FILE P.I. #0000313
STP00-0000-00(313)
GDOT District 4 - Tifton
Ben Hill, Irwin Counties
SR 107 From West of CR 264/Irwin
to SR 11/US 129/Ben Hill
Reconstruction/Rehabilitation

SUBJECT **APPROVED REVISED CONCEPT REPORT**

REVISED PROJECT CONCEPT REPORT

Project Number: STP00-0000-00(313)
County: Ben Hill and Irwin
P. I. Number: 0000313
Federal Route Number: None
State Route Number: S.R. 107

TYPICAL SECTION #1

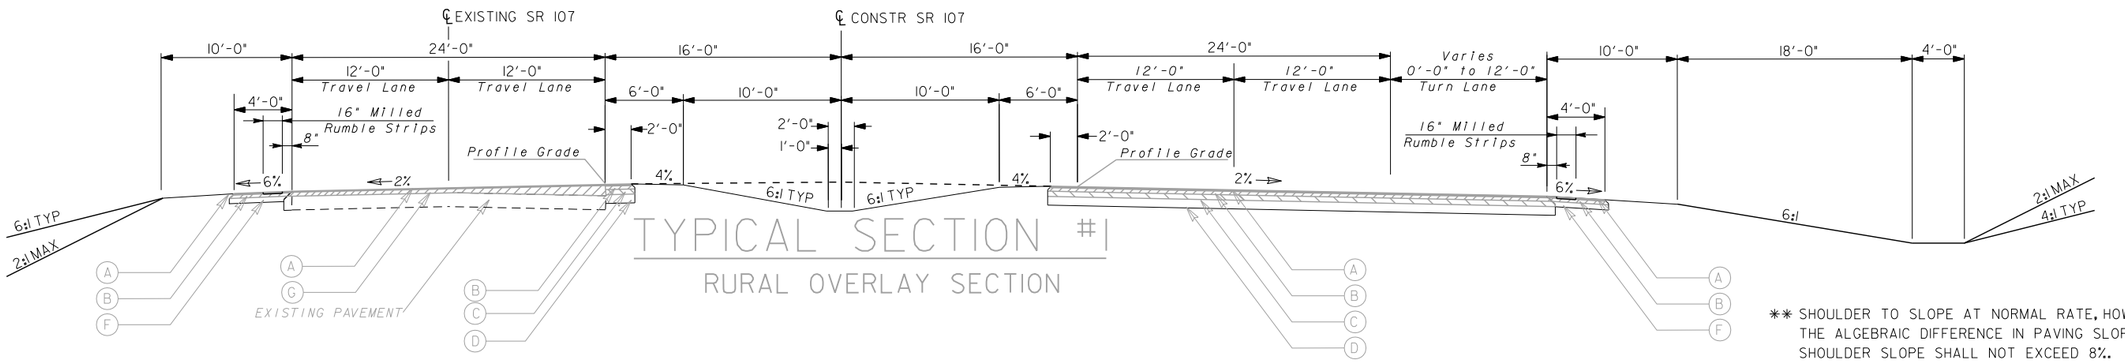
Approved Features:	**Proposed Features:**
• Typical Section(s), Rural – 44' depressed median with 6.5'/3.5' paved/graded shoulder and 200' of right of way. Urban – 24' raised median with 16' border area including 30" curb & gutter and 5' sidewalk on both sides and 120' of right of way.	• Typical Section(s), Rural – 32' depressed median with 4.0'/6.0' paved/graded shoulder and 190' of right of way. Urban – 18' raised median with 12' border area including 24" curb & gutter and 5' sidewalk on the north side only and 114' of right of way.

REVISED CONCEPT LAYOUT
STP00-0000-00(313)
P.I. 0000313
BEN HILL/ IRWIN COUNTIES
SR 107 FROM CR 264 TO SR 11/ US129
SEPTEMBER 23, 2011
SHEET 1 OF 4

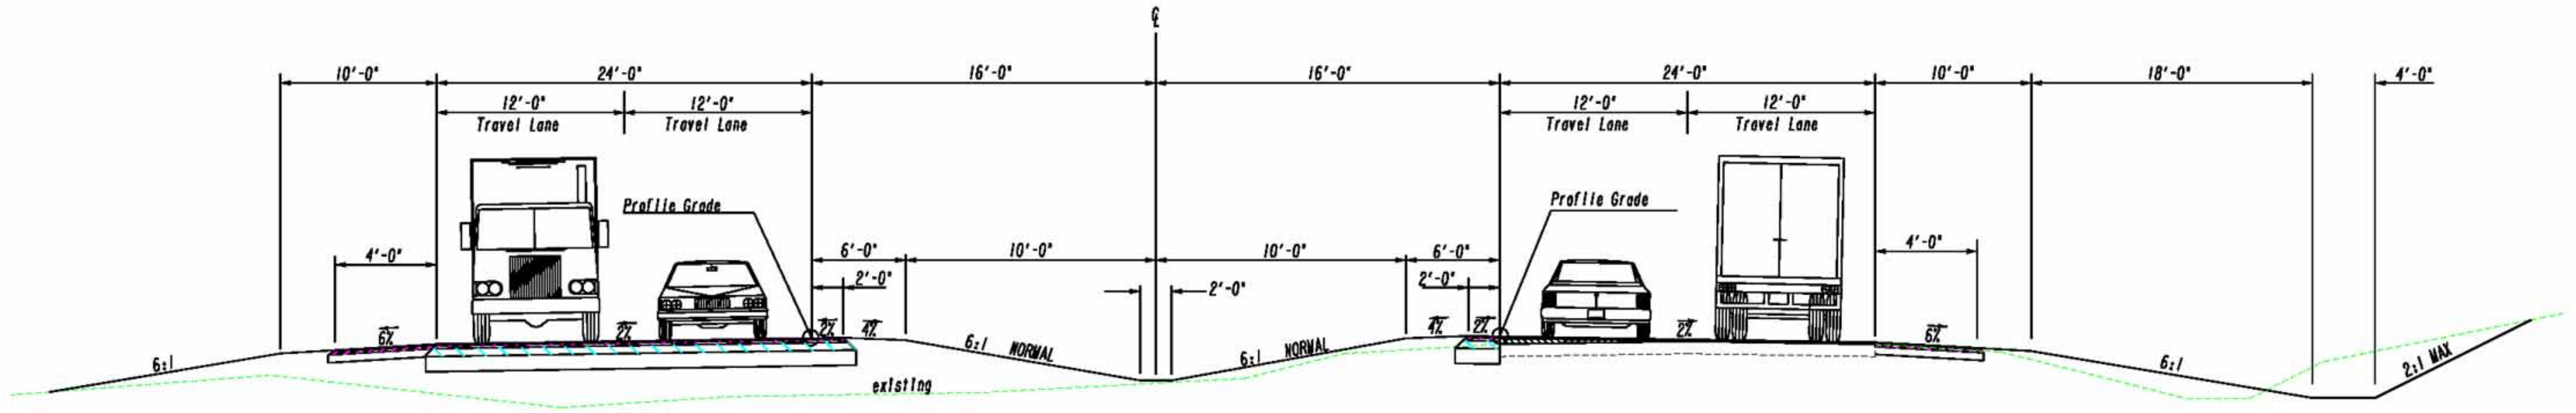
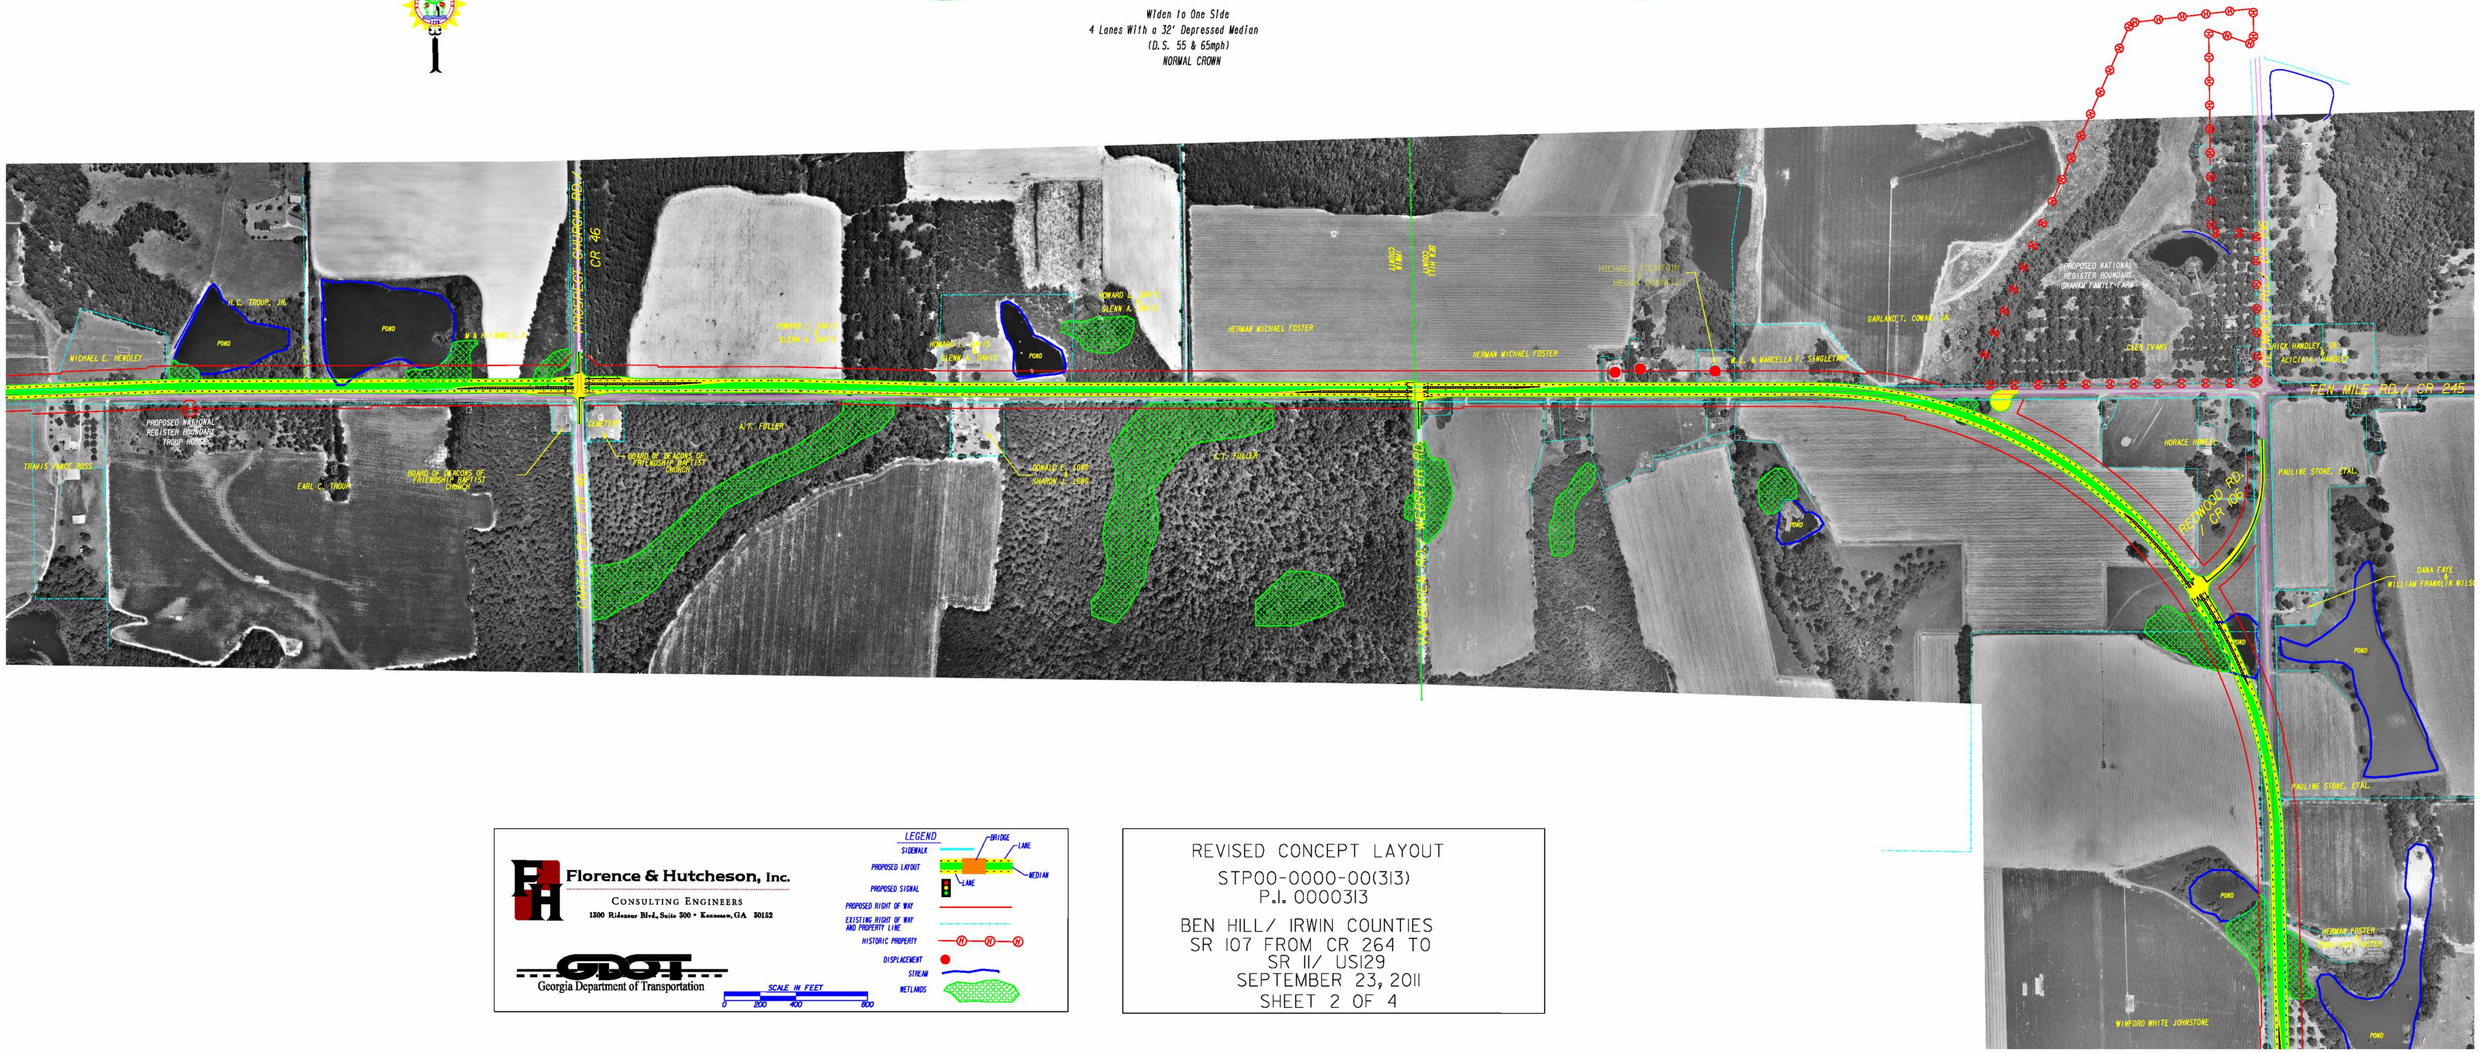
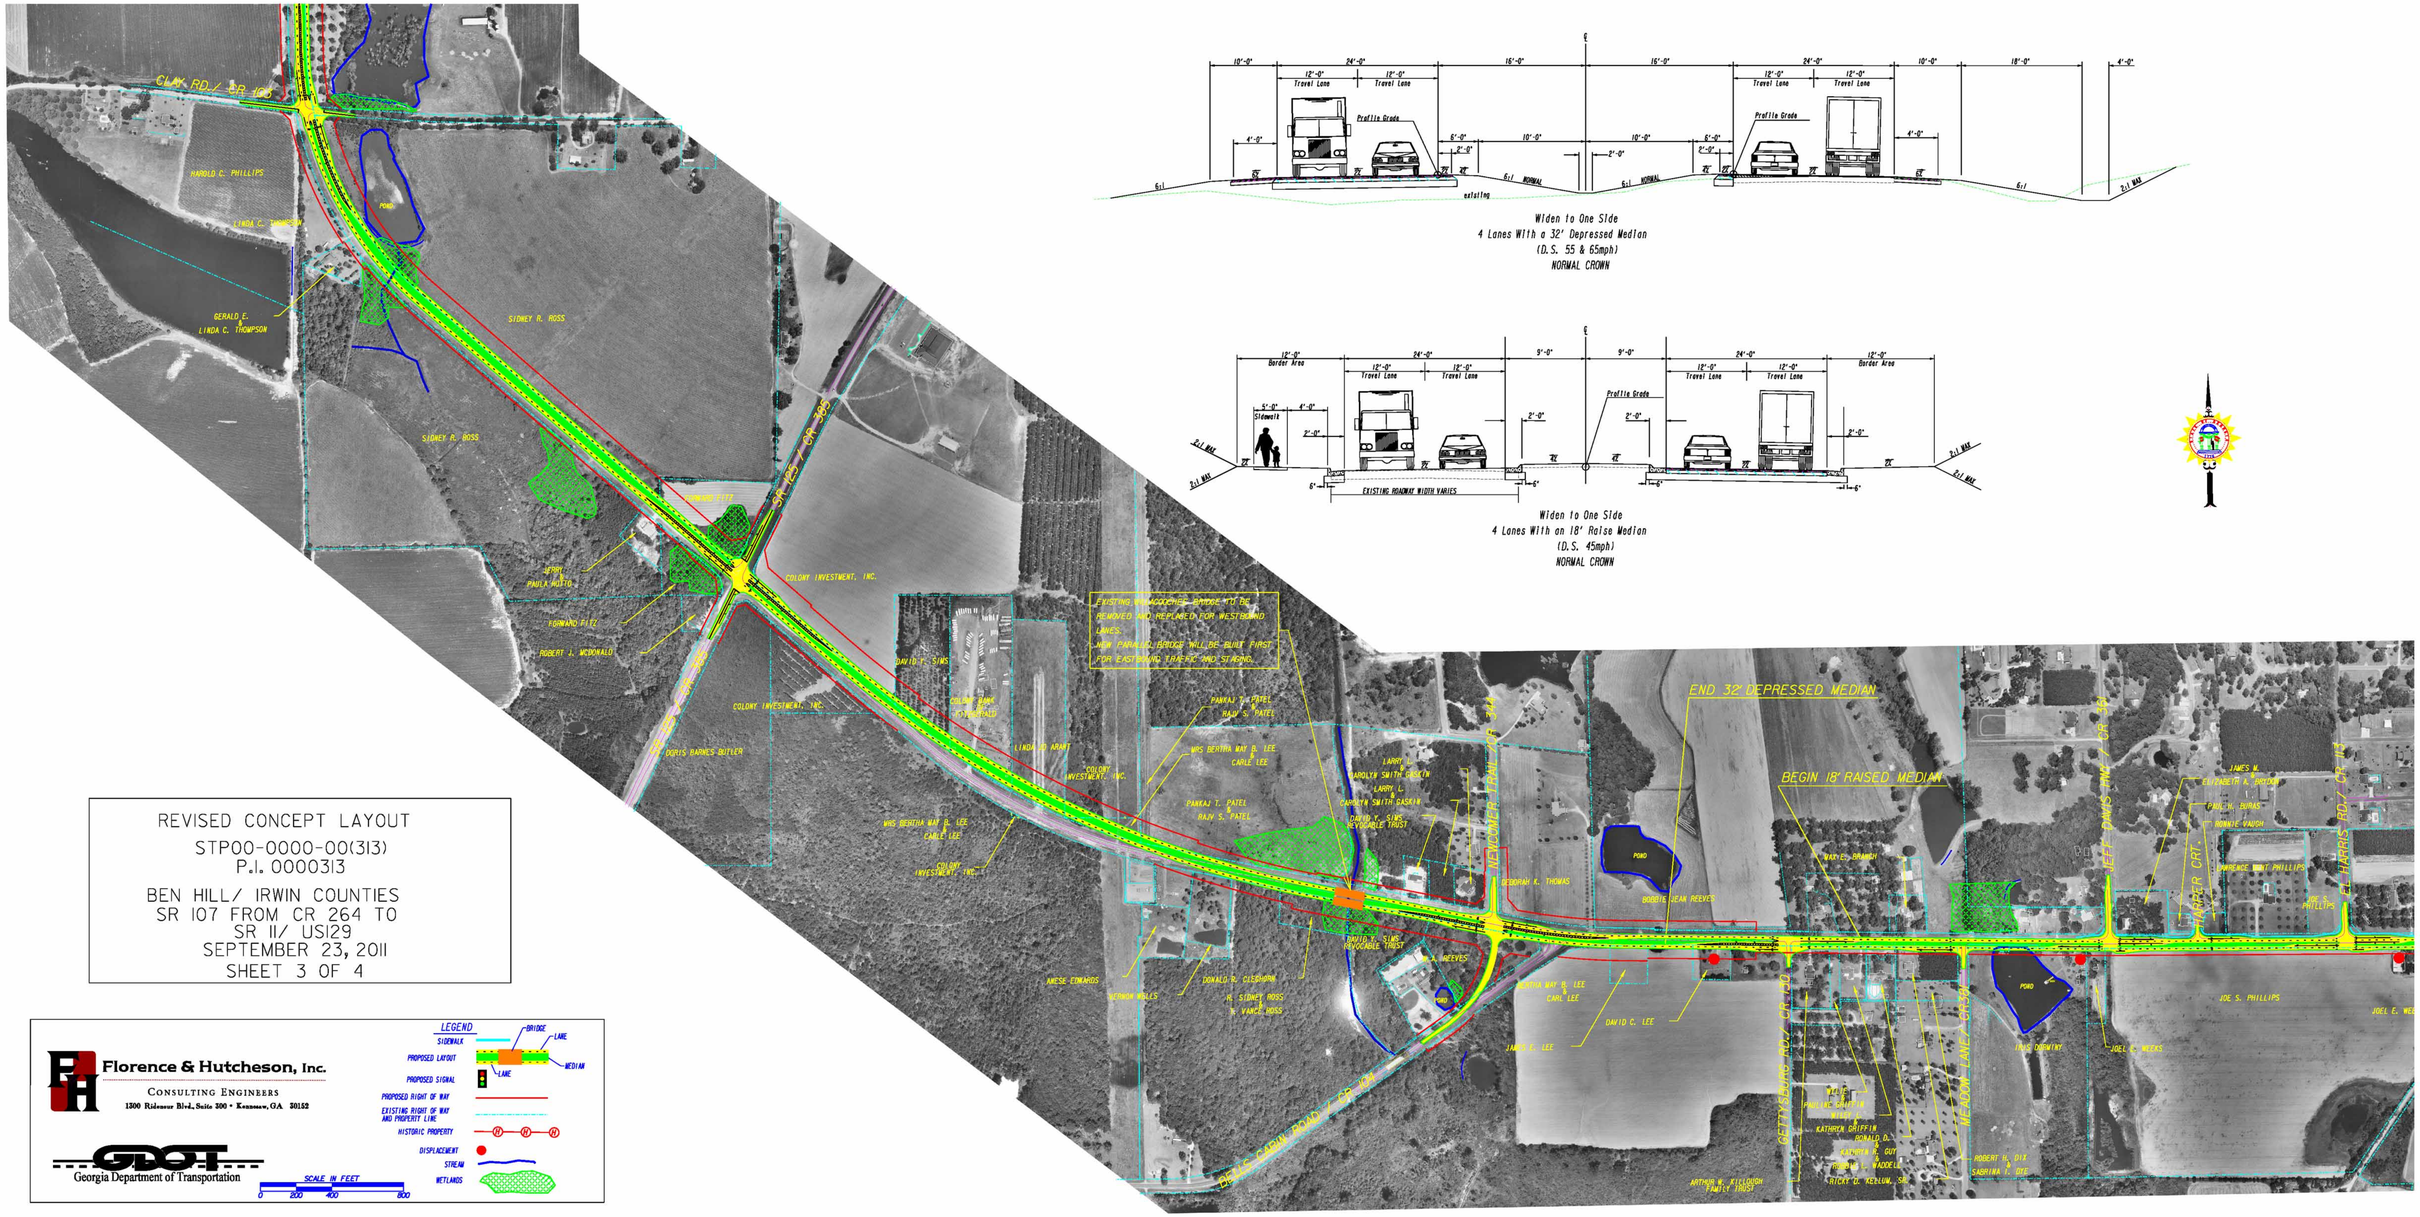
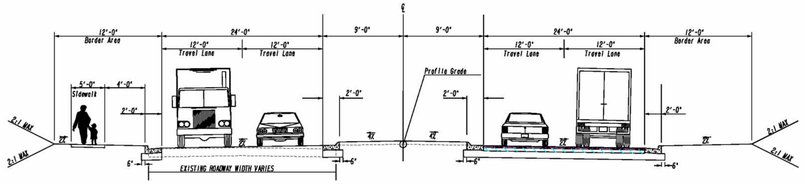
To reduce right of way limits and environmental impacts, the following is proposed as suggested from the Value Engineering Study: 1) Realignment of 5000' of mainline due to a reduction in the curve radii 2) Modifications to the typical sections by means of A) Reducing the median width from 44' to 32' in the rural section and 24' to 18' in the urban B) Changing rural paved shoulder from 6.5' to 4' and urban border area width from 16' to 12' C) Using 24" curb & gutter in lieu of 30" D) Eliminating sidewalk on south side of urban section 3) Shorten left turn lanes to minimum allowable deceleration length.

• Intersection of S.R. 107 and Redwood Road – New alignment 3,274.05' radius curve	• Intersection of S.R. 107 and Redwood Road – New alignment 2,600.00' radius curve
Reason for Change: The above changes are part of the implementation of the Value Engineering Study for this project which reduce right of way limits and environmental impacts as well as to reduce construction costs for paving, concrete, earthwork, and pipes.
